Official information request – Follow up to OIA IRO-339 – Resource Consent Application.

Water Services Resource Consent Conditions – Assessment of Application Rev C

Date: 01 August 2022 updated 12 August 2022, final 24 August 2022

SR510418 – Jervois Quay

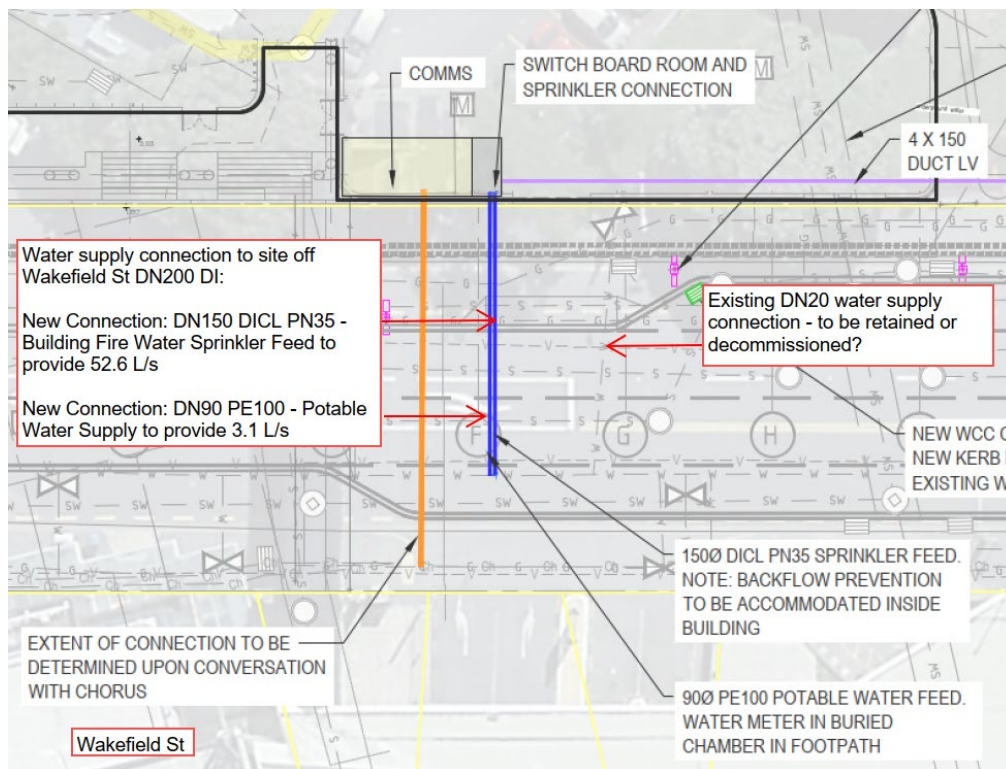
The applicant has indicated on their drawing (520408-0000-DRG-CC-0010-A) that they intend to install 2 new connections into the Wakefield Street DN200 DI watermain in order to service the development:

- DN150 DI CL PN35 – Building Fire Water Sprinkler Feed
- DN90 PE100 Potable Water Supply

These 2 no. new connections appear to be near the location of the existing DN20 water supply connection off the DN200 DI Wakefield Street watermain. The existing connections are not suitable for re-use and will need to be abandoned.

The WWL modelling team have indicated that there is 75-80 m of pressure in the water supply network at the point connection into the DN200 DI Wakefield Street watermain. This modelling result is based on a 2018 model which does not factor in future and proposed and developments. The applicant has advised a fire demand of 52.6 L/s and a domestic flow of 3.1 L/s. Calculations are required to support the assessment and demonstrate that this can be achieved from the public network.

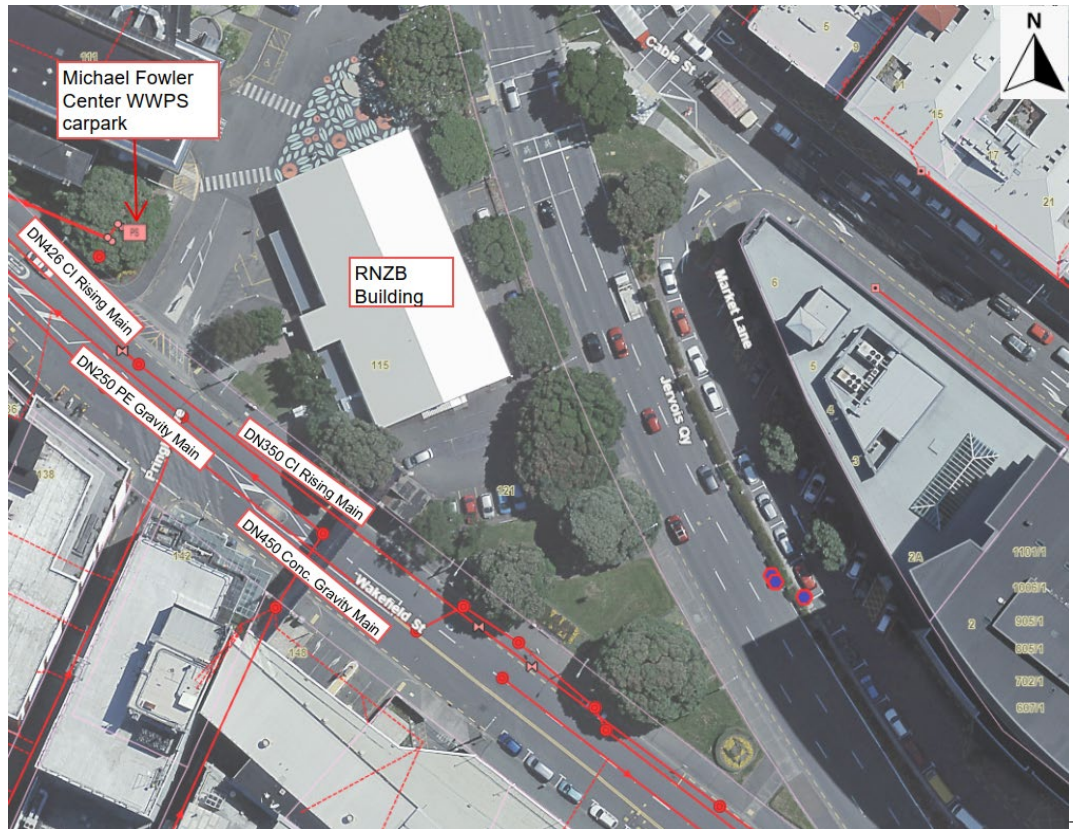
There are numerous wastewater pipes along Wakefield Street.

The applicant indicates that there is an existing WW service lateral which services the RNZB building (DN unknown). The applicant's drawing suggests that this service lateral connects directly in to the existing DN350 CI Rising main on Wakefield Street although, their reporting and labels indicate they have mistaken this to the DN450 Gravity main.

The applicant has indicated that there is an existing WW storage tank onsite. This tank is adjacent to the RNZB building and is beneath a road accessway. The tank provides storage for the adjacent WWPS located in the MFC car park and is a public wastewater asset. WWL have met with the applicant (22 June 2022) and, following receipt of a preliminary seismic assessment and a structural assessment have agreed a build over of the storage tank.

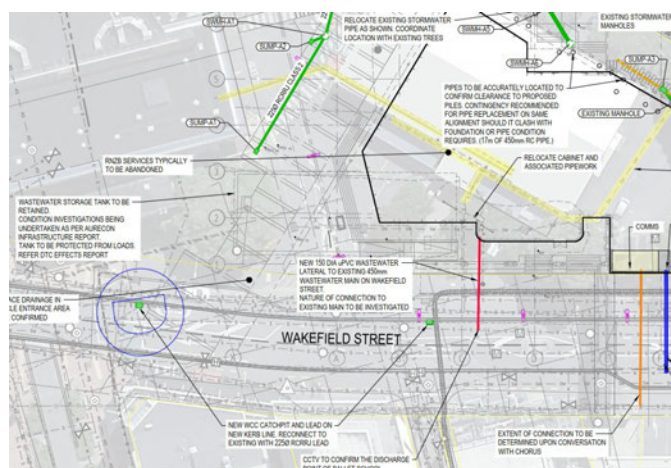
- Tank generally compliant with current codes + sea-level rise + potential hazard changes.
- The base of the tank is adequately socketed into the underlying alluviums (below potential liquefaction) to prevent lateral displacement of the tank.

- Unbalanced, seismically induced lateral earth pressures may result in minor settlements (50-100mm) across (or along) the tank. This could result in a small tilt (approx. 0.5 degrees max).

- Tank displacements minimal, proposed pile clearances are satisfactory.
- Flexural demands on tank due to passive soil pressures and pile reactions (for a 1-in-1000 year event) are well within existing tank capacity.

- It is apparent that original design allowed for worst case buoyancy (water at ground level).
- Removal of overburden at eastern end of tank (where proposed to build over) may reduce factors of safety below minimum. Anchor piles or ballast may be required.

- 24/7 access to the tank for heavy vehicles must be maintained at all times.
- WWL need to be able to safely undertake long term repairs / refurbishment / renewal. An easement should be granted in favour of WCC to ensure the access.
- The building tenants recognise that this a critical infrastructure item which is prone to noisy / smelly maintenance from time to time.

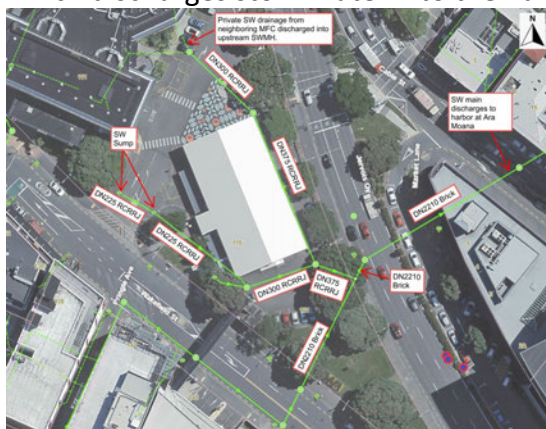
The SW infrastructure onsite receives SW discharge from a private network which services the neighboring MFC.

The SW infrastructure onsite comprises a series of sumps, pipes and mh's which ultimately drain into the 2210mm wide x 1220mm high ovoid stormwater main which discharges stormwater into the harbor at the location of the Ara Moana.

The applicant undertook to complete a CCTV inspection of the 2210mm x 1220mm ovoid stormwater main. CCTV footage confirms this pipe is ovoid in shape, is

WWL have confirmed (email correspondence, Samir Hermiz) that the existing ovoid stormwater main is at and over design capacity during peak stormwater events and need to remain accessible for upgrade / repair.

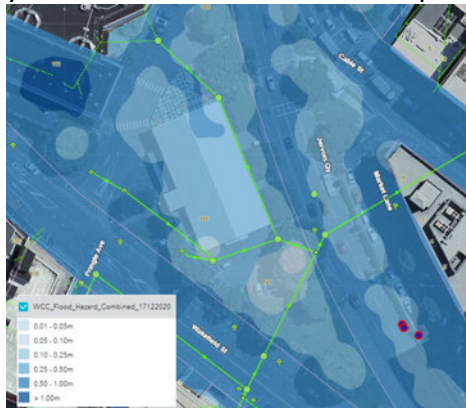
WWL flood maps indicate that the site is at risk of flood (0.01 – 0.5m) during 1/100 year flood events. The flood maps indicate the flooding varies across the site.

The applicant has undertaken some initial flood risk assessment (Aurecon). Simulations were run for 1/100 ARI event with allowance for the effects of climate change. Model results indicate:

- 20 mm increase for 10 year ARI + Climate change
- 30 mm increase for 100 year ARI + Climate change

These results indicate that most existing buildings in the area of the proposed development can be expected to flood in a 100yr ARI+CC event. The results have been demonstrated to be less than minor and as the flooding in this area is largely tidal it is not considered that further mitigation is required.

Model results confirm the proposed development floor levels to be marginally higher than the existing building. WWL confirmed with the applicant's result that based on modelling results the FFL of the development should be >3.03 m (200 mm above the RL of the 100yr+CC simulation model result of 2.83 m)

- 1) A 200 mm freeboard is acceptable given the tolerances / certainty provided within the model.
- 2) Freeboard is typically applied to the base of the concrete slab to protect the damp proof membrane from being effected by flood water.

The applicant has confirmed that the floor can be constructed to be resilient to potential flood effects. On this basis, and the basis of the assessment above the proposed FFL to the top of the floor slab is considered acceptable. A condition should be put on the consent requiring the floor to be flood resilient.

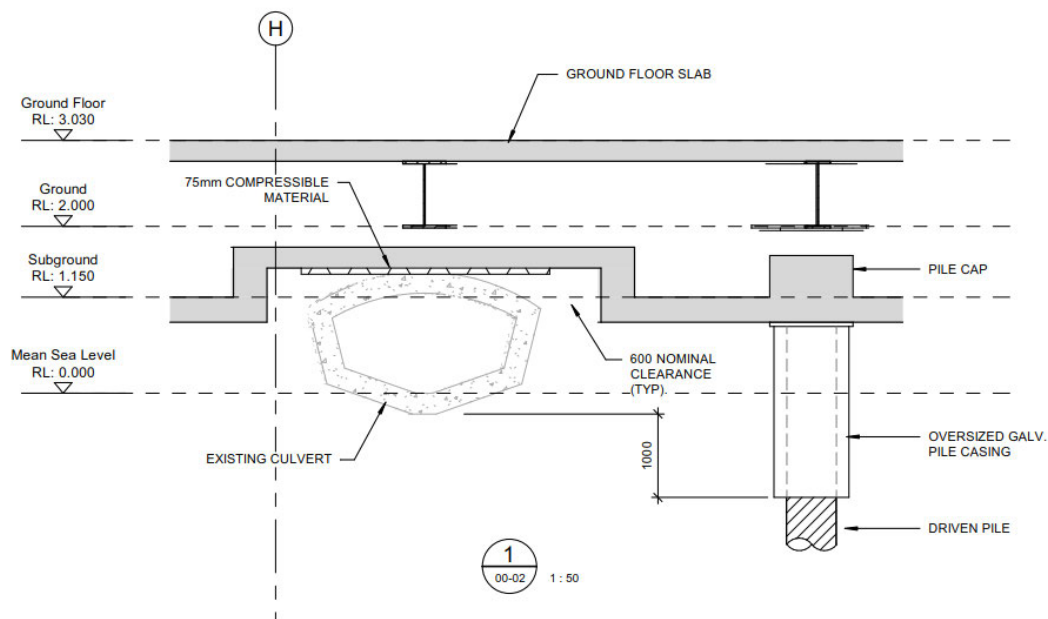
capacity during SW events – SW neutrality or betterment for this development is required as a result.

The applicant is proposing to retain the existing ovoid stormwater main and has designed the building to allow long term maintenance access to be retained such that the main can be repaired in the future if required.

- the final structural bay at the eastern end of the building would be cantilevered from L1 up, such that no foundations would be built over the culvert.
- the ground floor would be constructed of easily demountable walls and a lightweight surface treatment (e.g. similar to pavement) would form the floor, allowing easy access for any work required on the culvert in the future.
- the space would be used by building occupiers for bike parking or something similar – a use which can be relatively easily relocated at short notice.
- the cost of demounting and reconstructing this space would fall to the building owner. This would be captured in an easement instrument which would also protect WW's rights to access and repair/maintain the culvert.

The ovoid pipe has an IL of approximately 0 m and with the building construction will be approximately 3 m below the ground floor slab. The Regional Specification for Water Services drawing DR09 any building above the main would need to be at least 4m above the proposed ground level (depth to IL + 1m). This would put the L1 cantilever at 7 m RL to the underside of the floor slab.

No planting will be accepted over the ovoid pipe.
